ADDENDUM #1

### SANFORD HALL ABATEMENT

THE UNIVERSITY OF NORTH CAROLINA AT CHARLOTTE CHARLOTTE, NORTH CAROLINA

DATE OF ISSUE – December 7, 2015

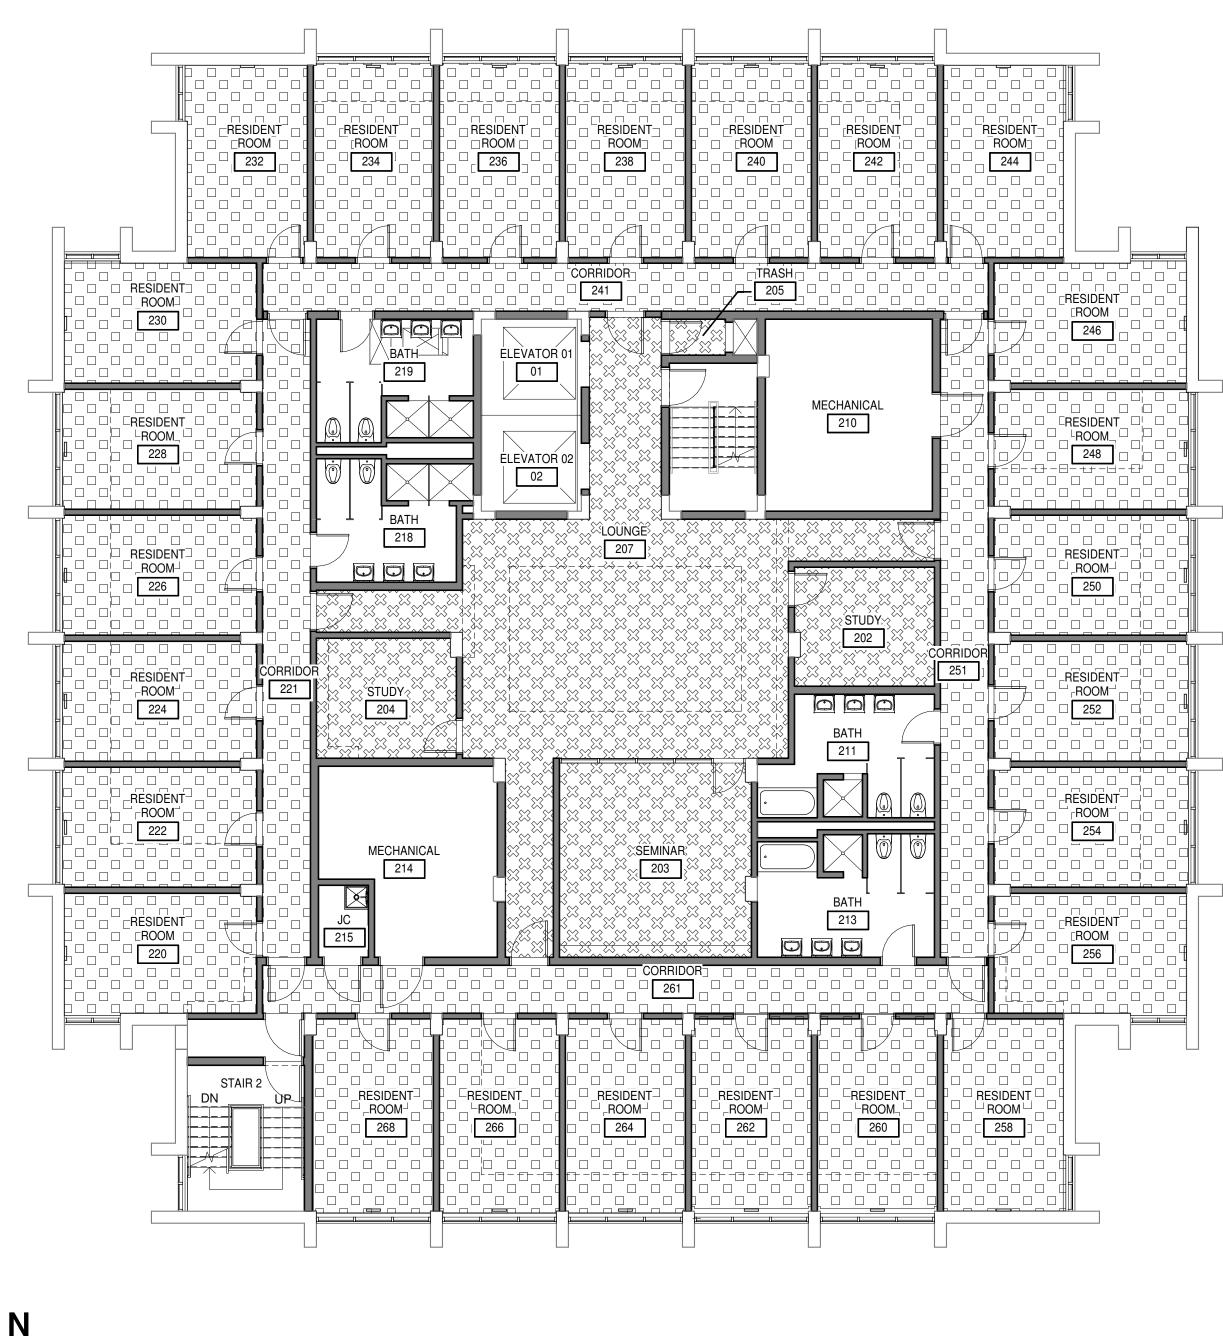
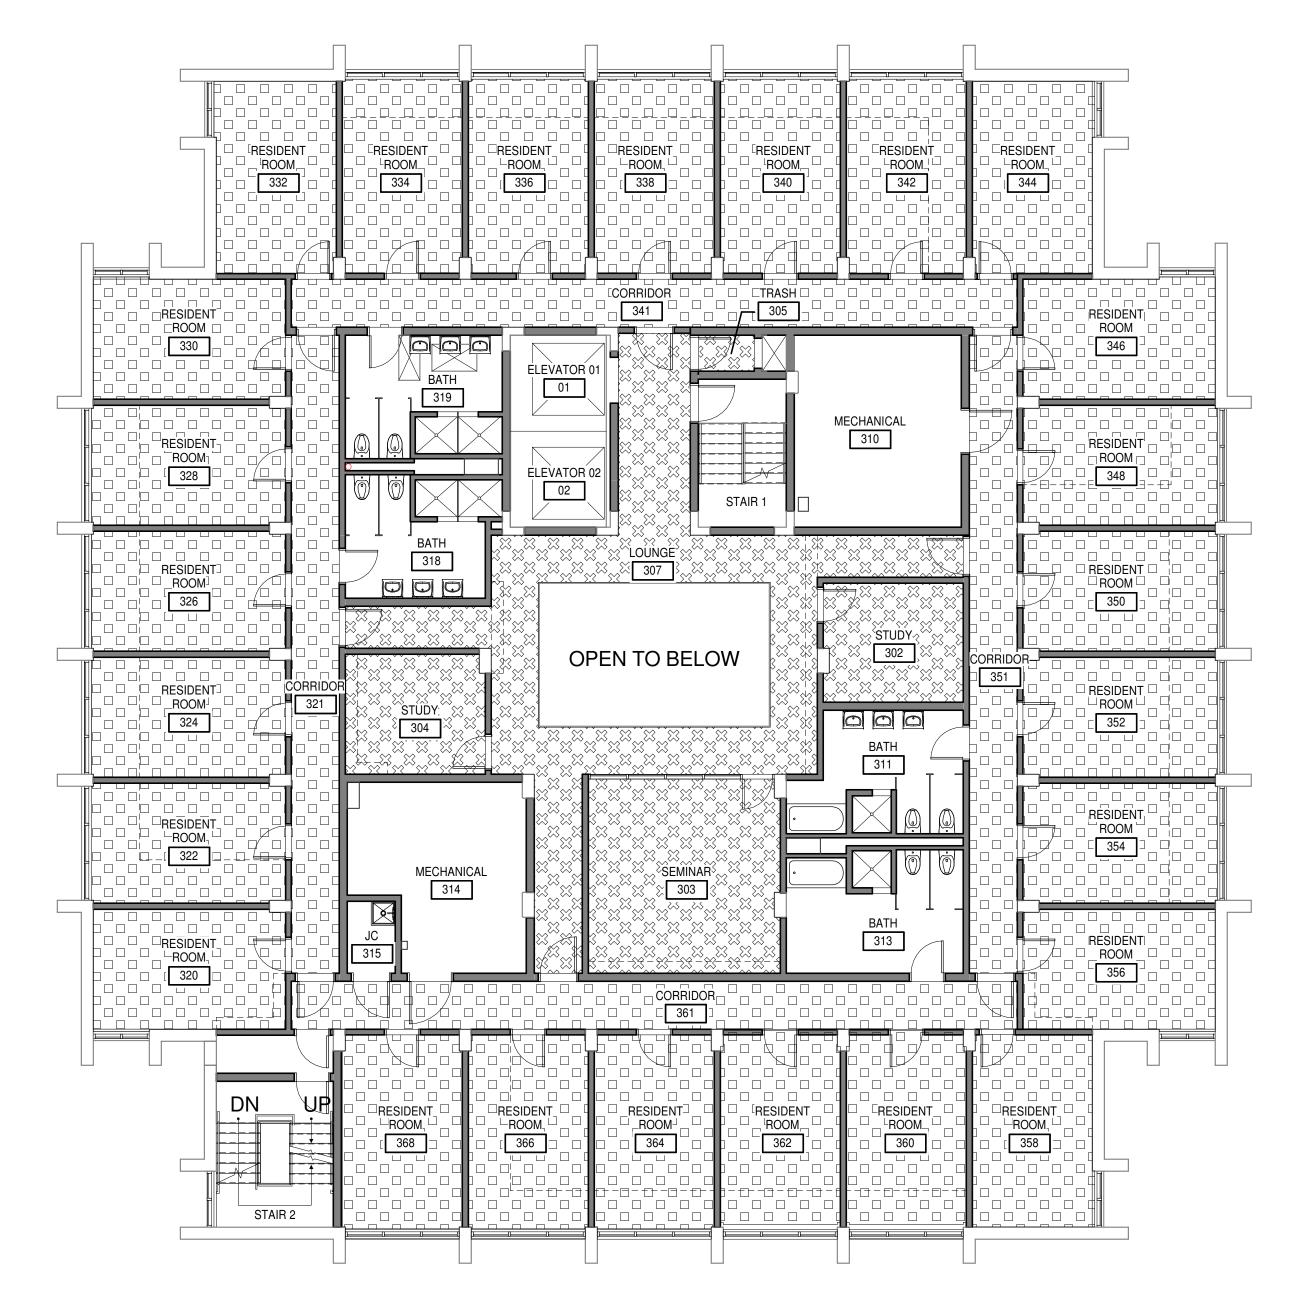
- General Notes: Note 8: <u>DELETE</u> "Contractor shall coordinate schedule for furniture reinstall with
   owner performed work that shall follow abatement activities on each floor."
- ADD General Note 10: "Ceiling mounted light fixtures shall be removed for ceiling abatement and reinstalled prior to project completion".
  - <u>ADD</u> General Note 11: "Wood trim at top of walls and surface mounted conduit shall remain at completion of the project".
- 34 35

A1.0.2

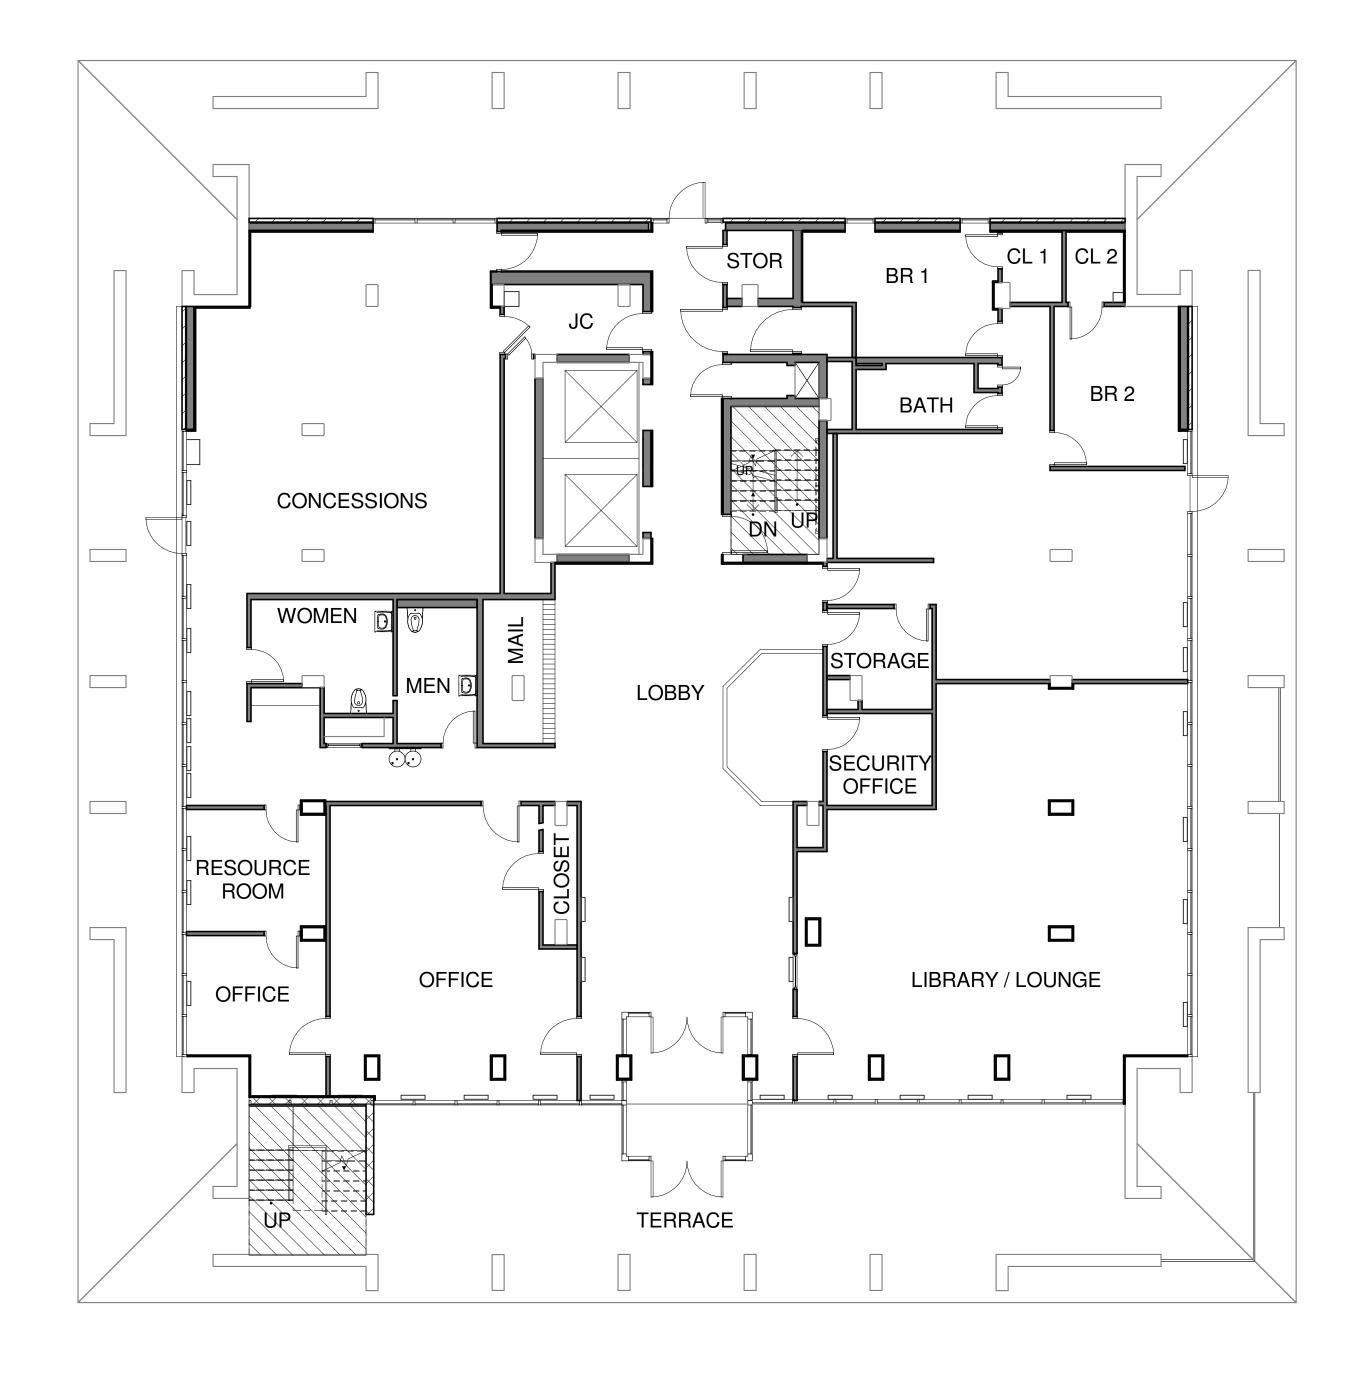
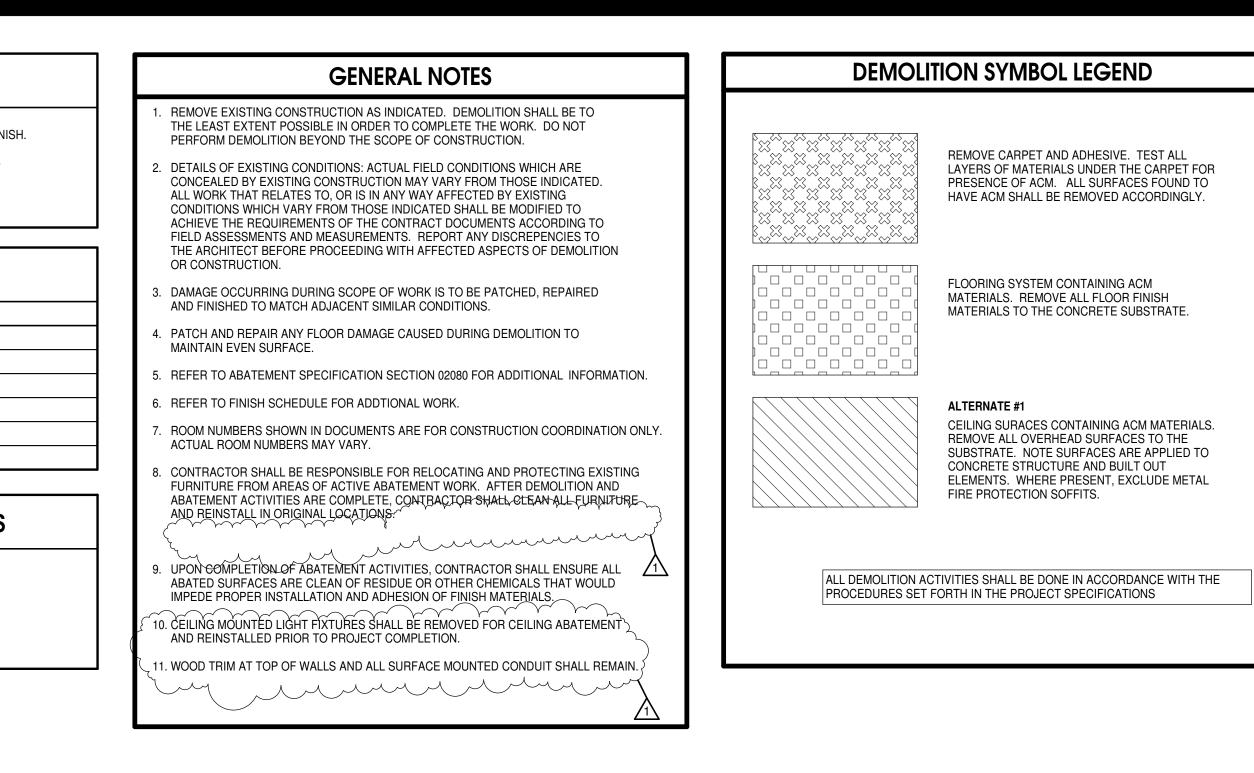
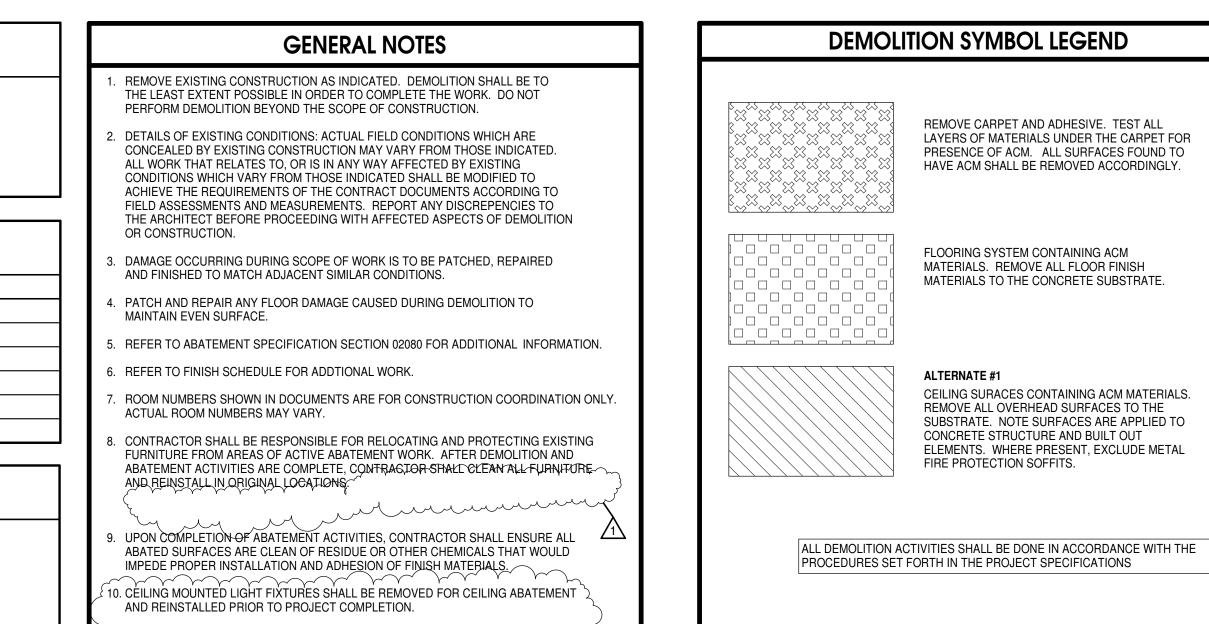
38 39	General Notes: Note 8: <u>DELETE</u> "Contractor shall coordinate schedule for furniture reinstall with owner performed work that shall follow abatement activities on each floor."
40 41 42	<u>ADD</u> General Note 10: "Ceiling mounted light fixtures shall be removed for ceiling abatement and reinstalled prior to project completion".
43 44 45	<u>ADD</u> General Note 11: "Wood trim at top of walls and surface mounted conduit shall remain at completion of the project".
46	DRAWING A1.0.3
47 48	General Notes: Note 8: <u>DELETE</u> "Contractor shall coordinate schedule for furniture reinstall with owner performed work that shall follow abatement activities on each floor."
49 50 51	<u>ADD</u> General Note 10: "Ceiling mounted light fixtures shall be removed for ceiling abatement and reinstalled prior to project completion".
52 53 54	<u>ADD</u> General Note 11: "Wood trim at top of walls and surface mounted conduit shall remain at completion of the project".
